INDESIT company

Model type:
AS60VEX

Commercial code:
F030652

Four feet have been installed on the dryers referred to in this release (see pictures N1040405FIG1-FIG2).

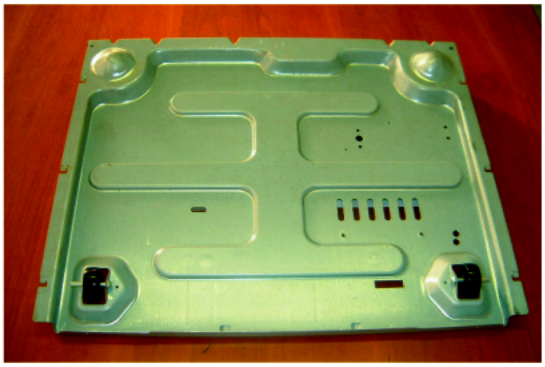
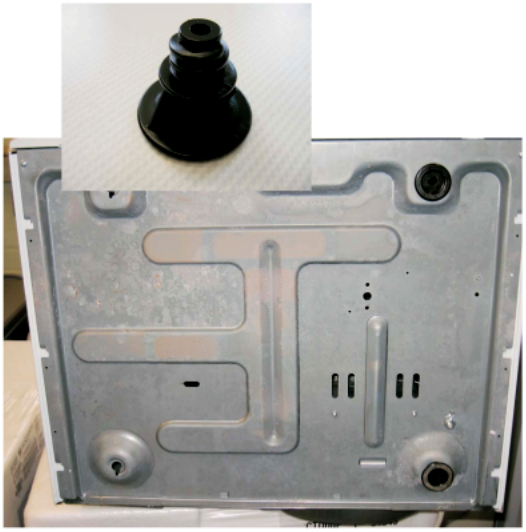
n1040405: Feet installed on dryers

New parts
C00142439 - foot
C00142908 - base

premodification parts
C00095591 - wheel
C00095592 - pivot
C00112148 - base

n4408c00: VENTED HEATER/THERMOSTATS

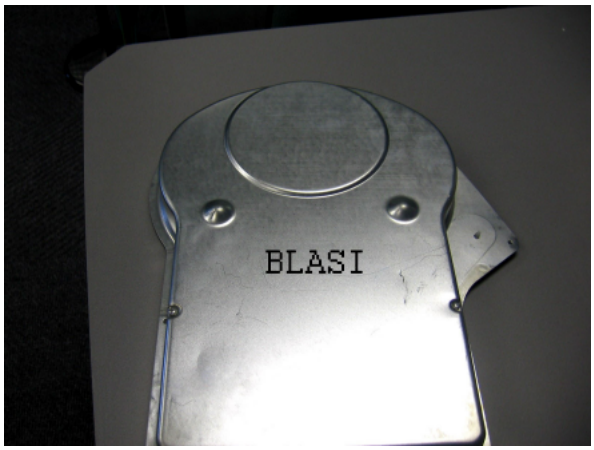
From Serial Number 70802.0001, two different heater manufacturers were used in production, DBK and Blasi. The DBK and Blasi Heaters are totally interchangeable if replaced as an assembly.

Attention,
The thermostat kits for these heaters are not interchangeable.

Identification,
The cover of the Blasi heater has 2 raised dome shaped pips, there is also a Blasi Label attached to the inside of the heater cover (photo N4408C00-BLASI).

The Cover of the DBK Heater has 4 raised dome shaped pips (photo N4408C00-DBK).
